MICHAEL MILLER BA. (Hons) ARCH. MCIAT
Architectural Consultant

YORK HOUSE, KING STREET, ROBIN HOODS BAY.
2018/0204/LB & 0232/FL

Thank you for your e-mail dated 29th May 2018, I have attached amended drawings for your information:

Drawing No. 193/03a
Date: DECEMBER 2017
Scale: 1/50

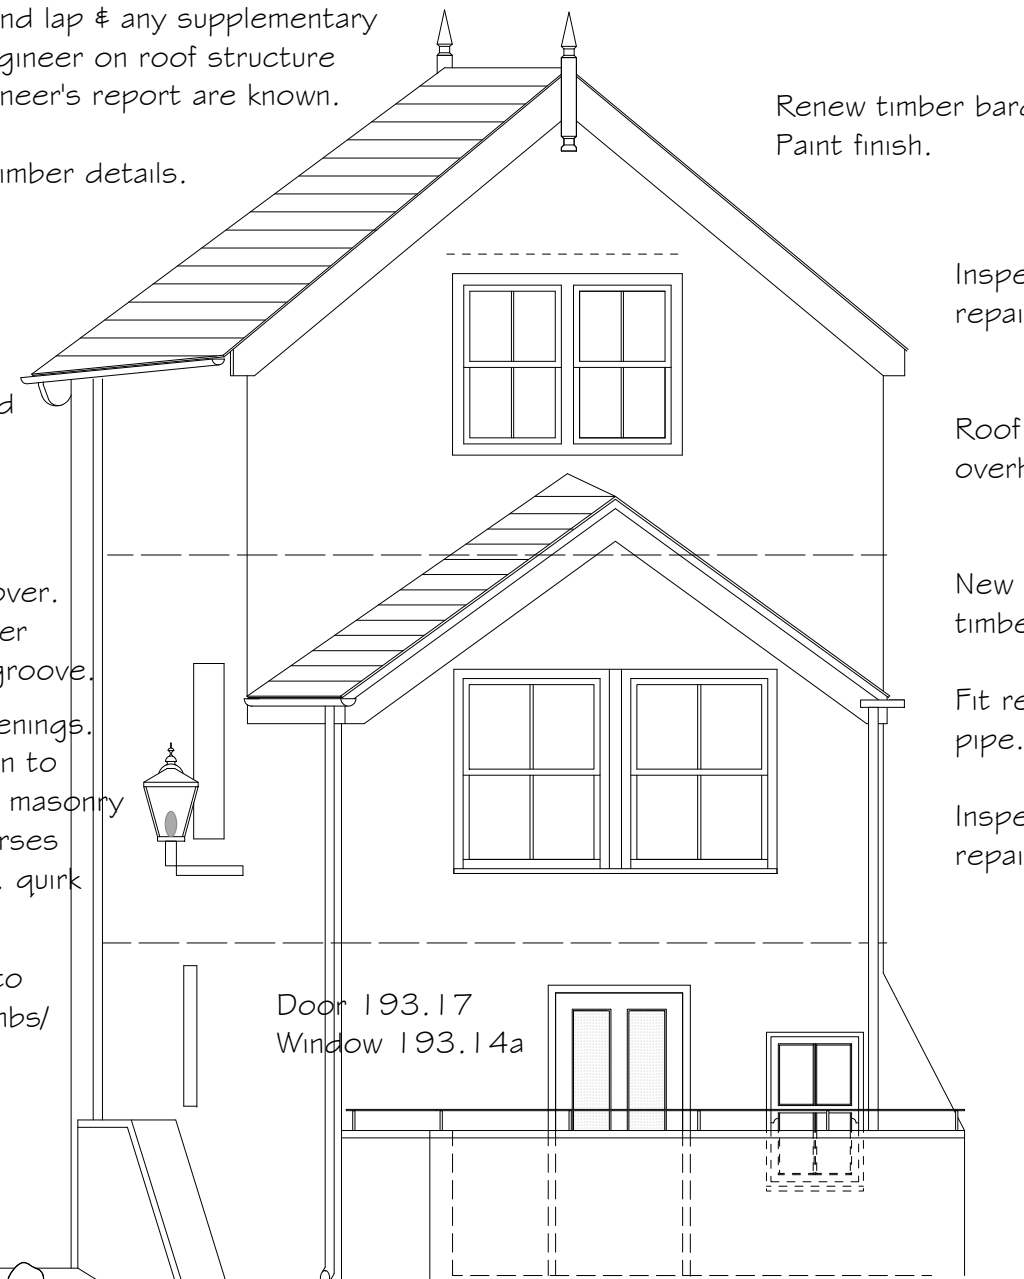
Revision A. 4.6.2018.
Notes re: extg slates to be re-laid. Need to consult Structural Engineer. SFL sill to remain + Helifix bars reinf. FFL window heads to remain Helifix bars reinf. FFL window sills.

Extg sill to remain (NYMNP) requirement. Structural Engineer's Report shows crack reinforcement and this should be extended to 300mm beyond lhs window opening.

Extg window heads to remain (NYMNP).
Precautionary measure: Install Helifix joint reinforcement above head & next course over. Bars butt joint with cover bar centrally over joint. Fix as manuf instructions in 50 mm groove.
Take out defective sills to FFL window openings. Replace with new or reclaimed sills section to match courses & fit between extg historic masonry as shown. Re-align stonework to 3no courses above bay window to form even panel incl. quirk bottom of central support masonry.

- 2.14 Front FFL window openings. Window head: I discussed this with Richard Agar Associates, Structural Engineers; the thinking was that;
 - a). An unequal ms angle would not work very well under the existing heads as there is not really a level course for insertion and;

- b). For this solution we concluded that there would be concern that a slip plane at the bearing could be the result of installing the metal allowing further movement of the stonework.

c). The idea of a flitch plate bolted from the inside was mooted, however there is not so much by way of material in the existing lintols to enable strong fixings to be achieved.

d). The most effective solution, given the preceding criteria, would be that the masonry bed joints are reinforced above the window heads with Helifix bars in a 50mm deep groove. The idea is shown on the front Elevation drawing.

2.15. Front SFL sill. Your preference is fine, discussed with R.A. Assoc, the bed joints should be reinforced with Helifix bars, the lengths extended to those shown in the Structural Engineer's Report.

Drawing No. 193/13a
Date: JANUARY 2018
Scale: 1/50

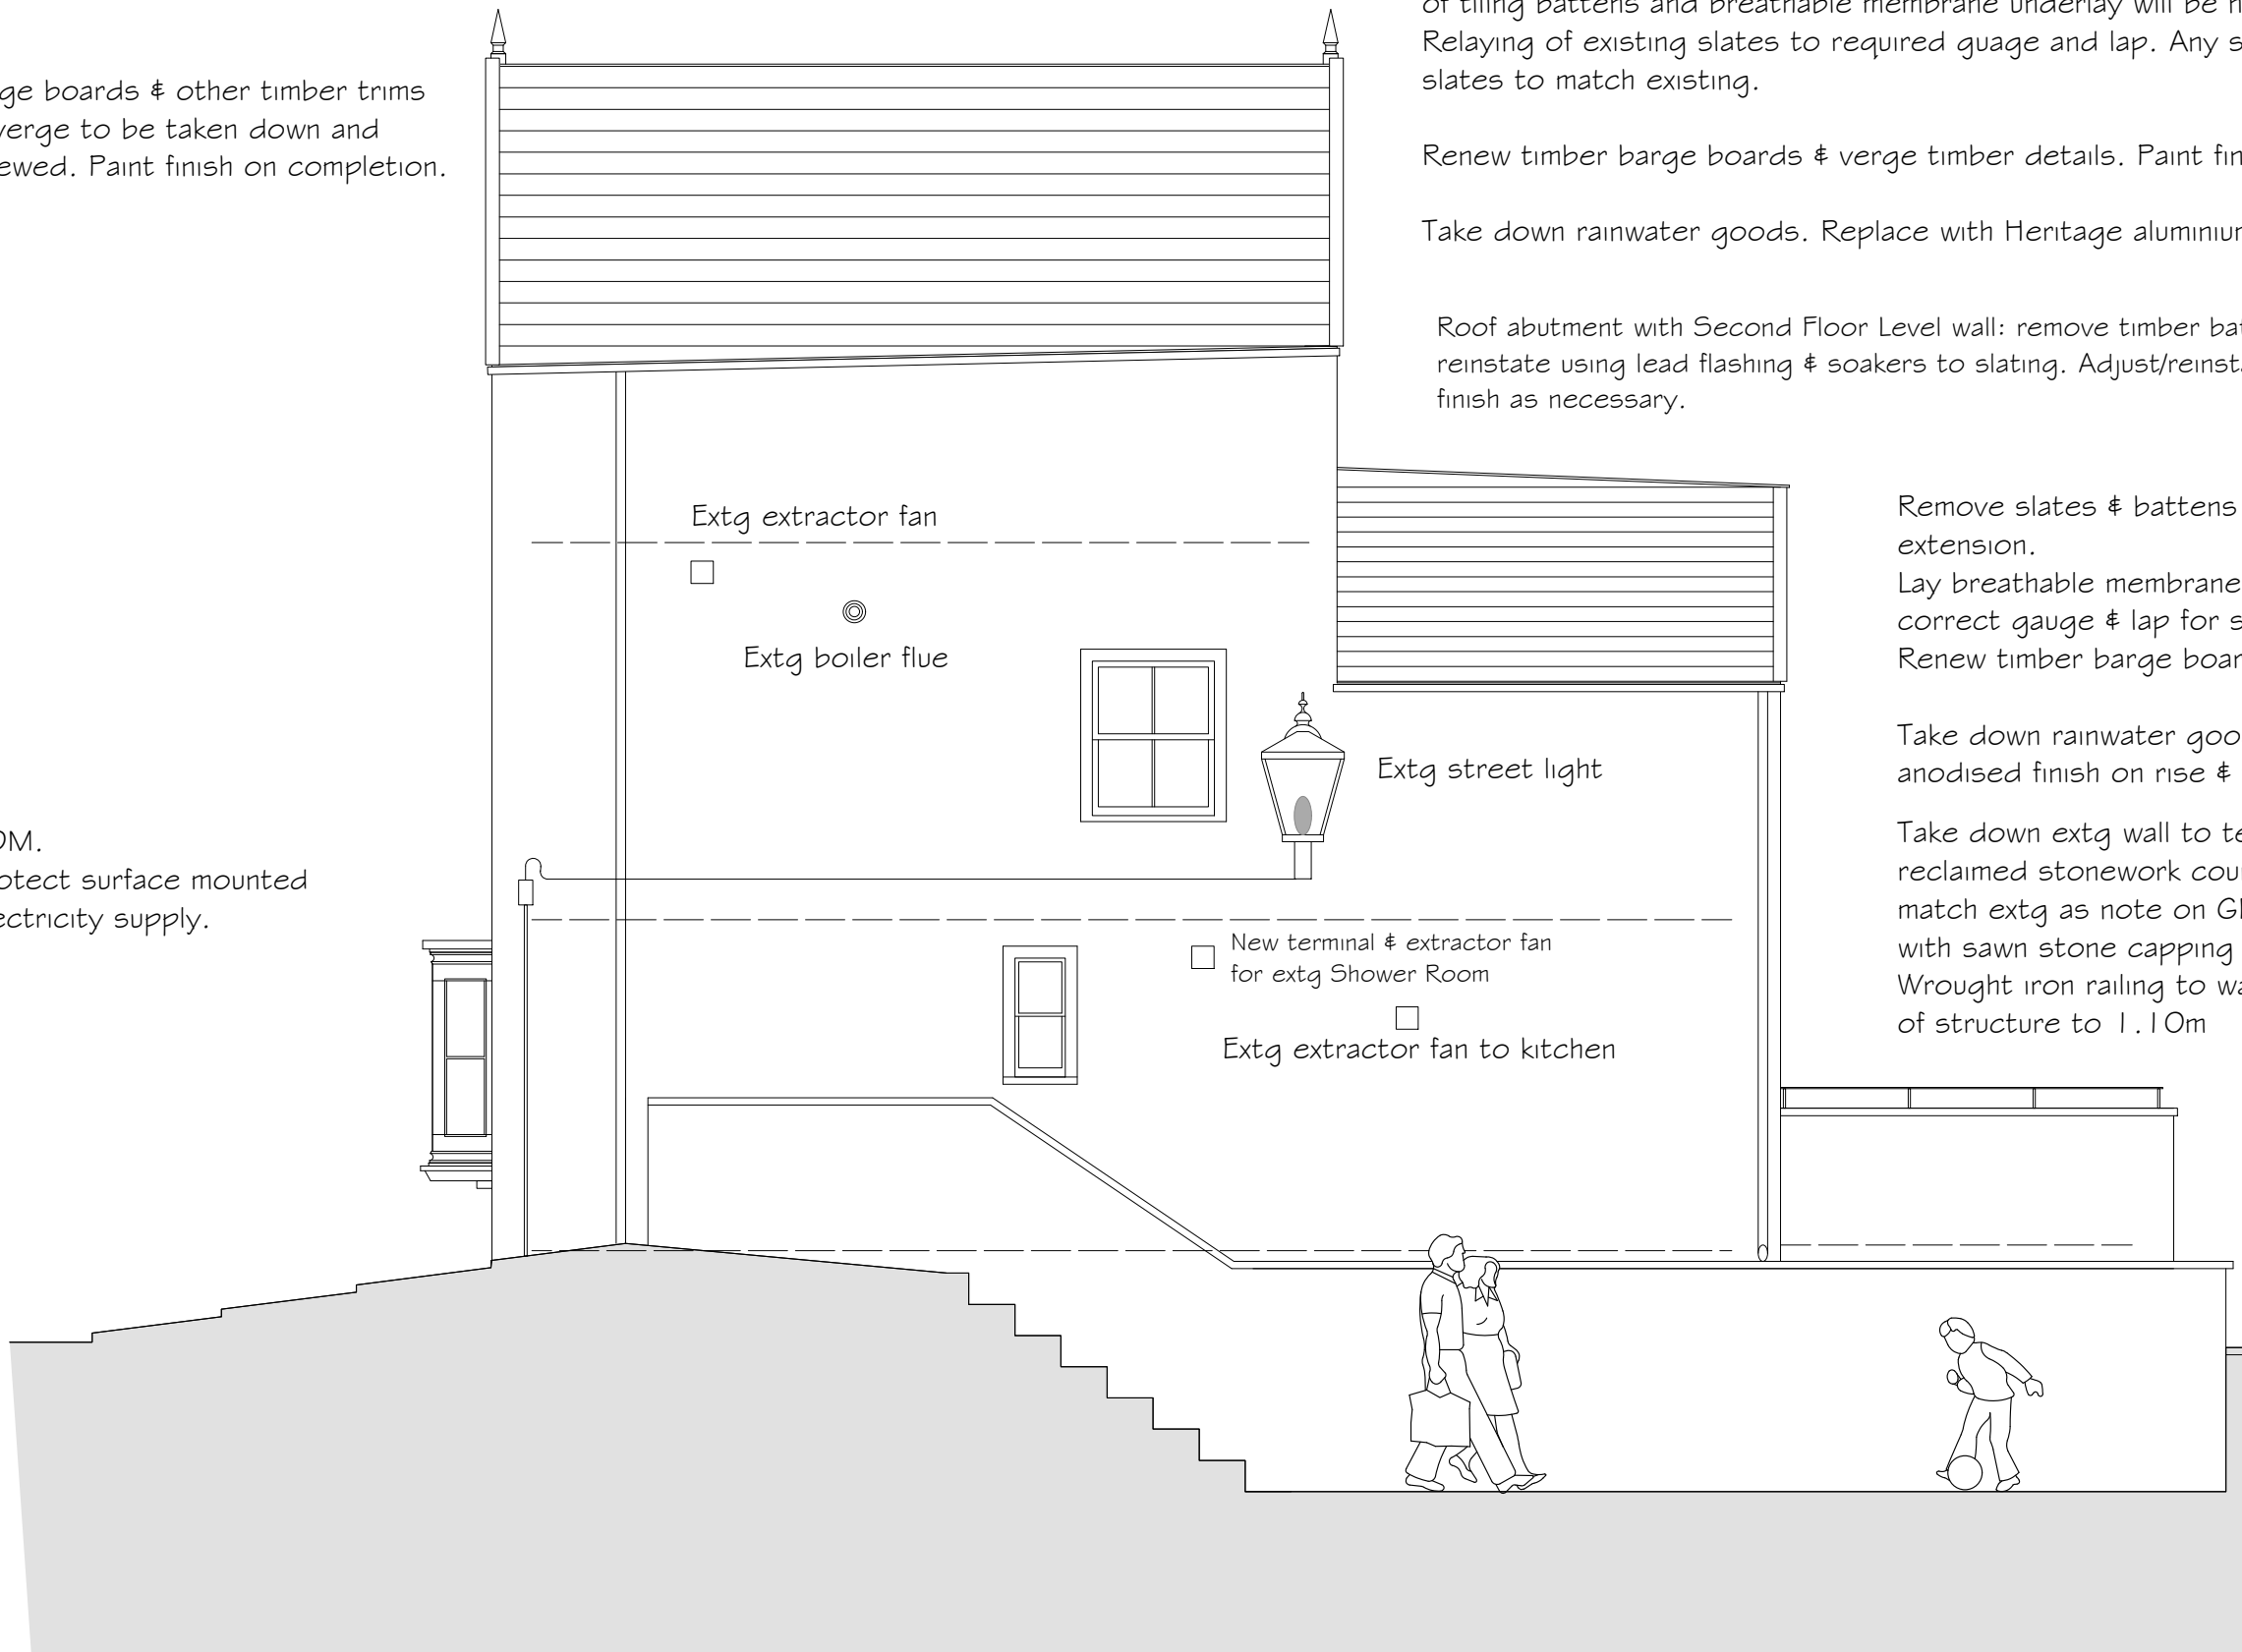
Extractor fan duct from new Shower Room to terminate at proprietary slate vent. Black colour.

Lay breathable membrane. New treated sw battens. Re-lay extg slates to
correct gauge & lap for size & location. Fix with copper nails.
Renew timber barge boards/plates & slate cover battens to match existing.

2.16. To clarify, the existing slates are to be re-laid. Supplementary slates are to match.

Drawing No. 193/10a
Date: JANUARY 2018
Scale: 1/50

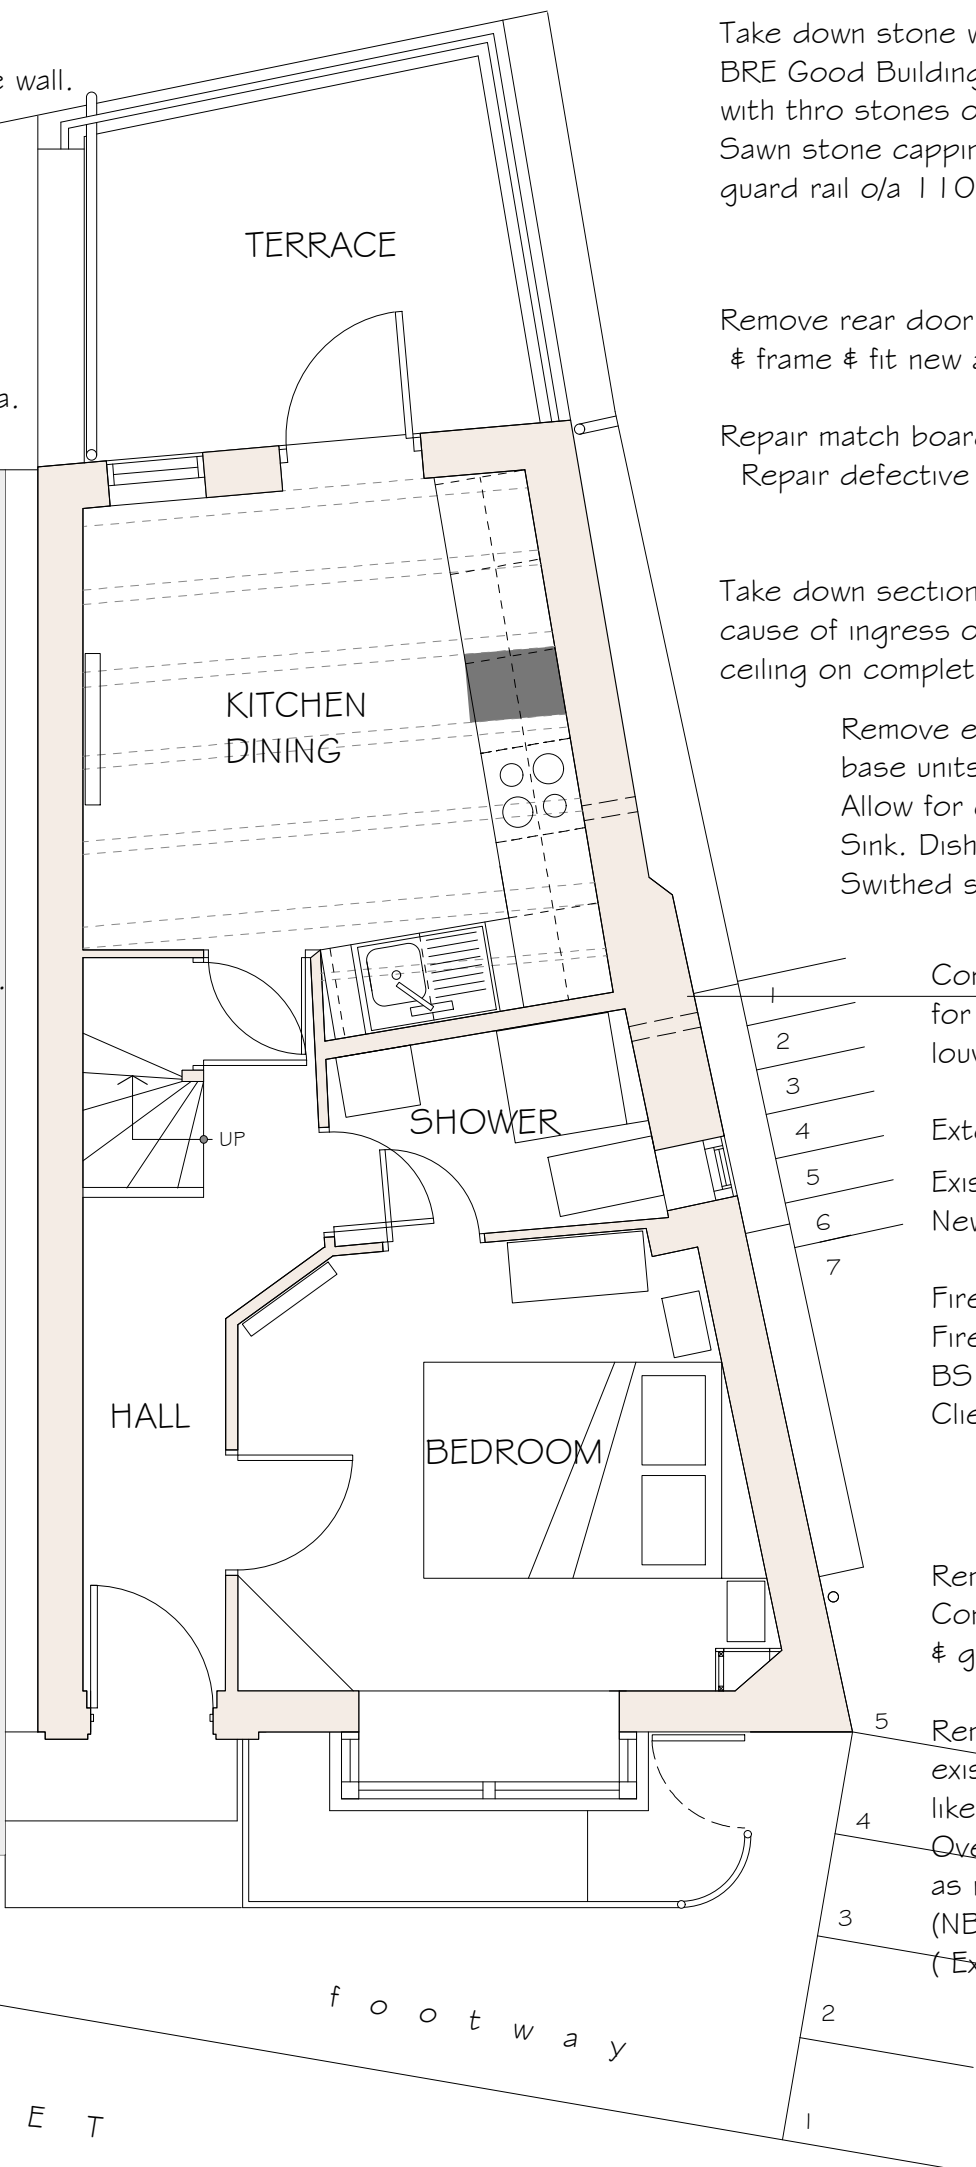
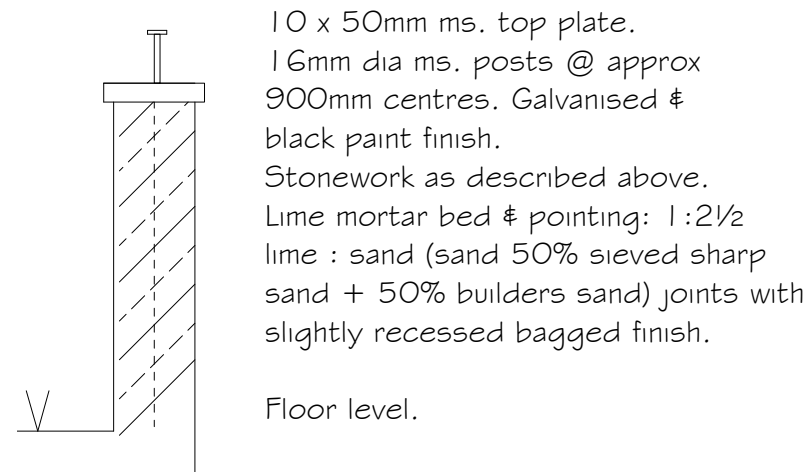
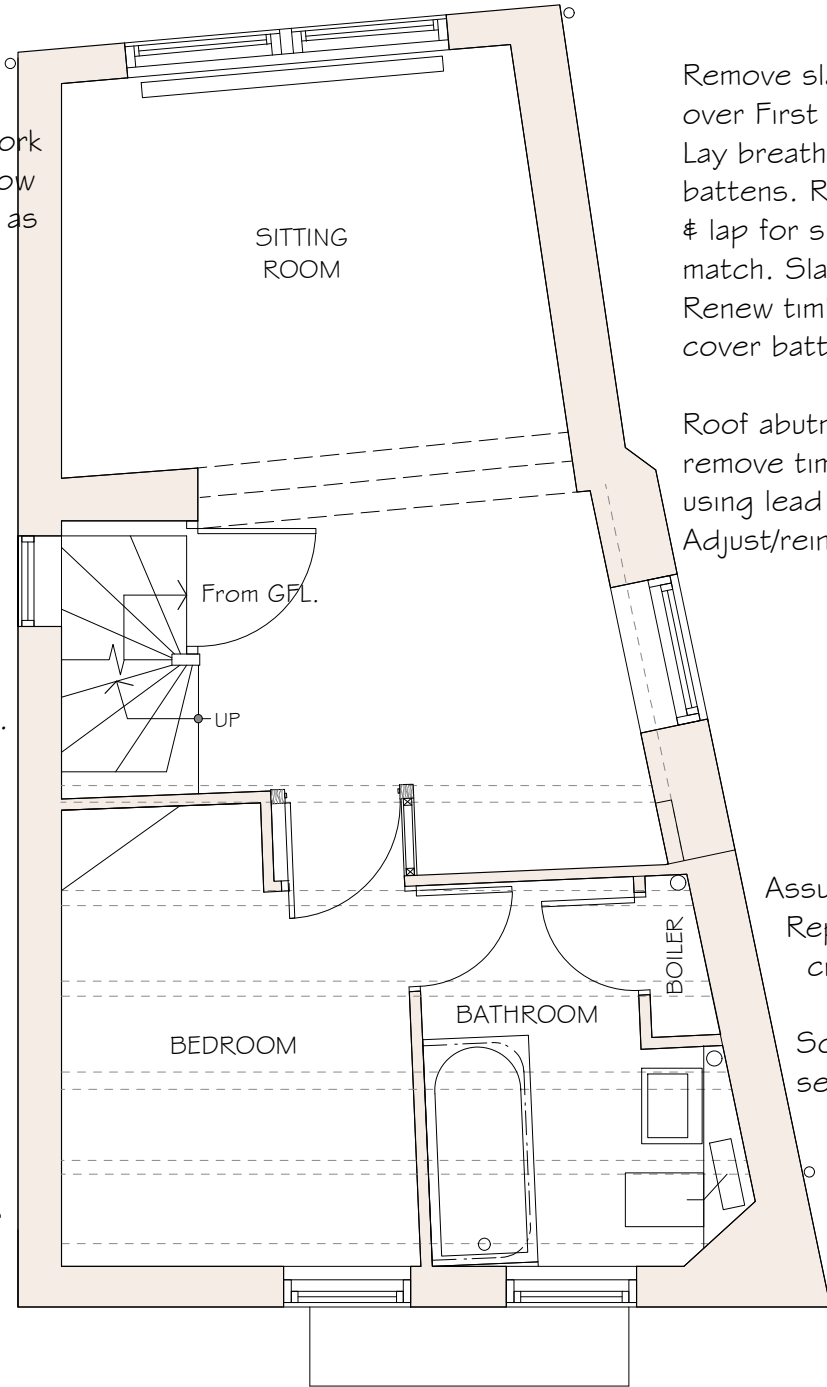
Take out existing standsheet window frame & replace with vertical sliding timber sash window as detail 193.14a.

Timber door to Kitchen/Hall to be repaired by regluing & cramping joints. Fill cracks etc & paint finish.

Front door to be refurbished by fitting draught seals to frame. Sections to suit gaps. Adjust door to allow for fitting low sill threshold seal. Alternatively replace exactly like-for-like.

Take down stone wall to terrace & rebuild in two skins fair face both sides min 215mm thick o/a. BRE Good Building Guide No. 14. Max height 1075mm. Coursing & faces to match existing & tied with thro stones or stainless steel ties @ 600mm centres horizontally & 450mm centres vertically. Sawn stone capping as neighbouring property & wrought iron railing approx 200mm height to form guard rail o/a 1100mm. CDM Working at height.

Revision A. 4.6.2018
Notes re: Terrace wall. Internal doors. Kitchen window. Front door. Front door external surround - base only. Shower Room extract fan.

- 2.01. Boundary wall – amended as your proposal.
- 2.02 Drawing amended to lead weight balanced sash. Sections altered.
- 2.03. Ok.
- 2.11 Front door, notes amended as you propose.

- 2.12. Yes, pilaster base only to be replaced. Notes added to drawings.
- 2.13 & 2.27. The applicant would prefer to wait until building work can be scheduled into the calendar before making any inspections to the Bay Window head so please 'Condition, that work.

2.25, 2.32, 2.36. Internal doors. Applicant happy to proceed as your suggestion to renovate re-glue/cramp, fill cracks and paint finish.

Following advice in the Structural Report, an extractor fan has been added to the Shower Room at Ground Floor Level.
